October 11, 2006  
W.O. 625-0813-400

**RE: ADDENDUM FOR CEQA HYDROLOGY REPORT AND STORMWATER  
MANAGEMENT REPORT FOR SUGARBUSH COUNTY OF SAN DIEGO TM-  
5295RPL3/R04-008/SP03-003/S04-015/LOG NO. 02-08-047.**

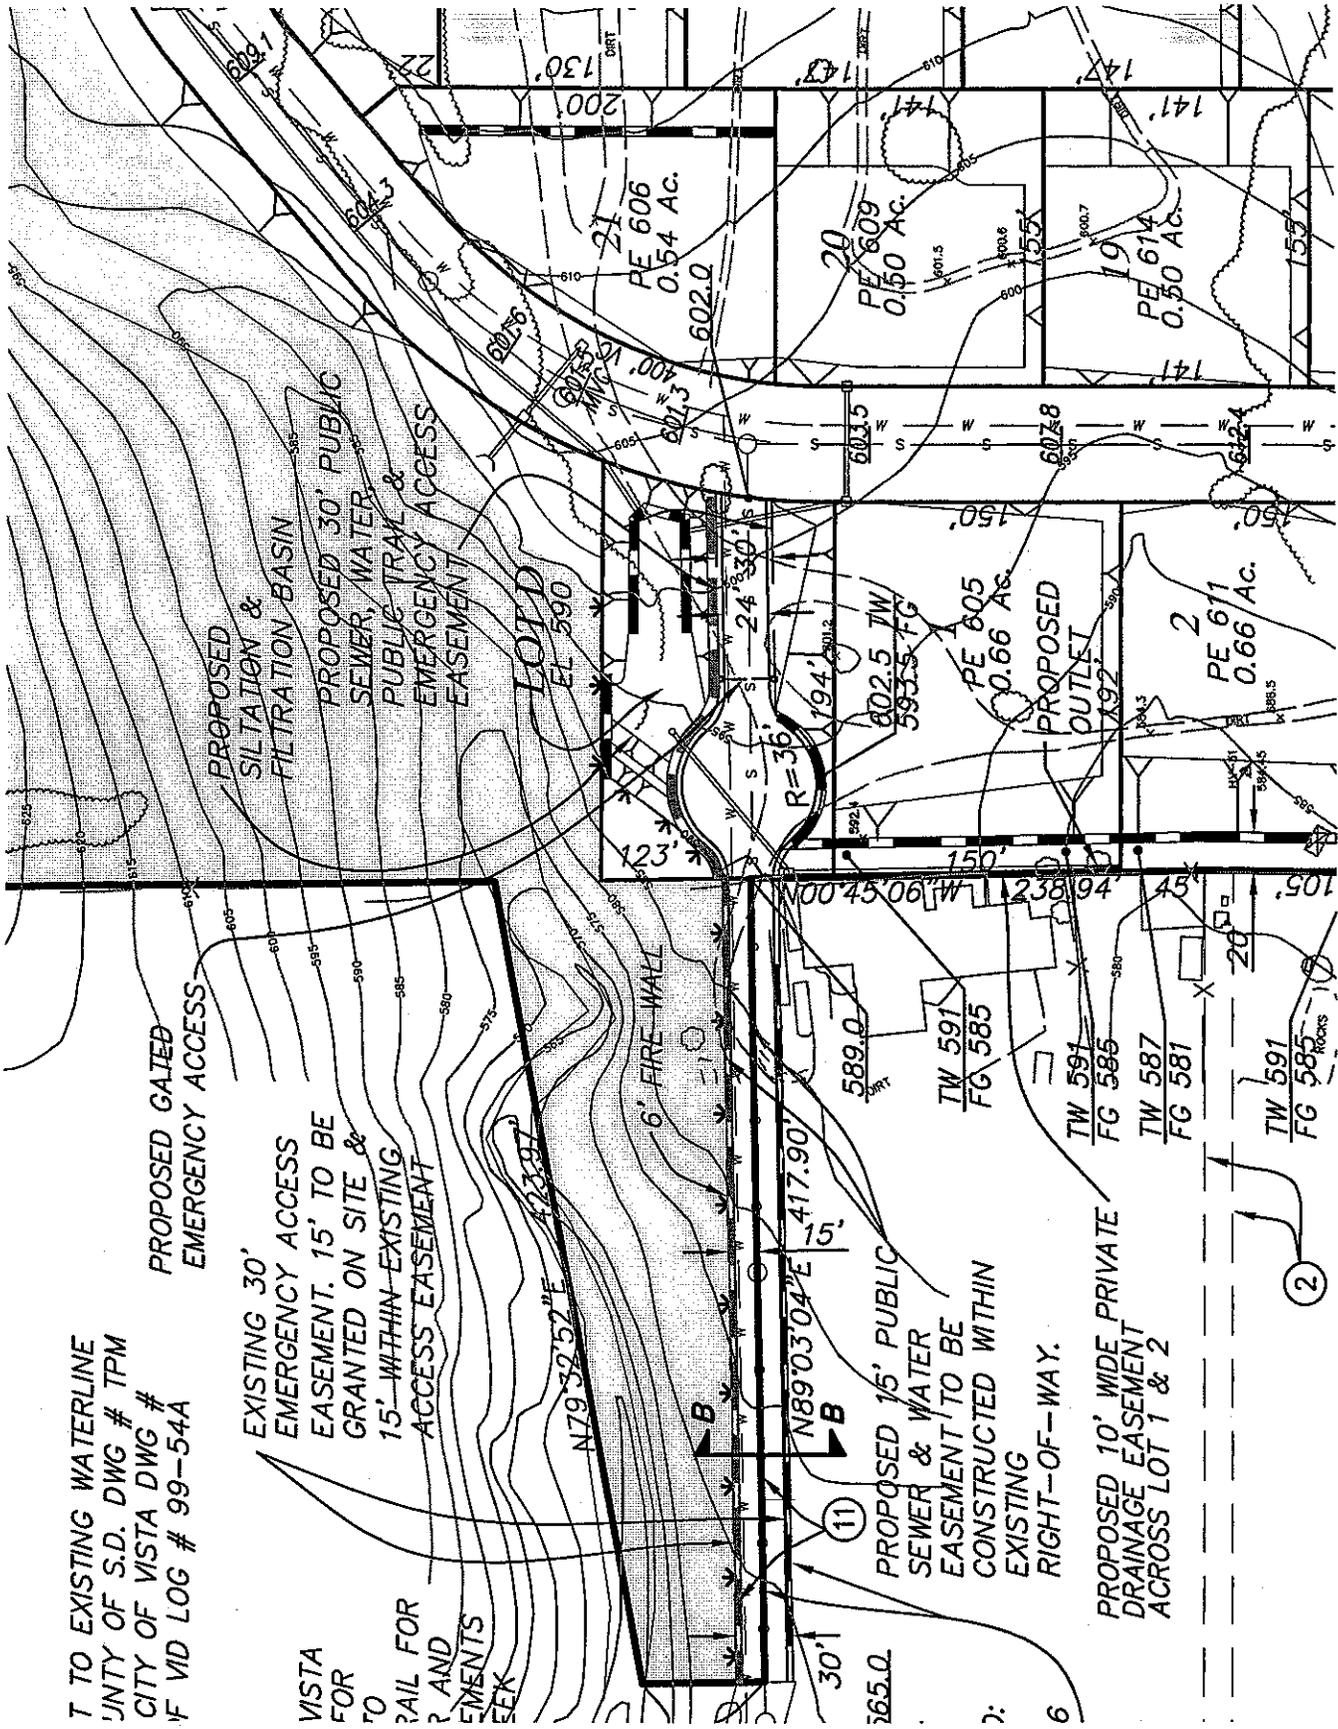
Due to the revised requirements from Vista Fire Protection District (VFPD), the emergency access has been relocated from Lone Oak Lane to Cleveland Trial. As a result, the proposed de-silting/filtration basin (Lot D) was reconfigured (see exhibit).

The proposed de-silting/filtration basin is only for water quality use and not for detention purposes. The proposed de-silting/filtration basin is adequate for water quality use. The actual configuration of the de-silting basin and outlet structure will be designed during the final engineering stage.
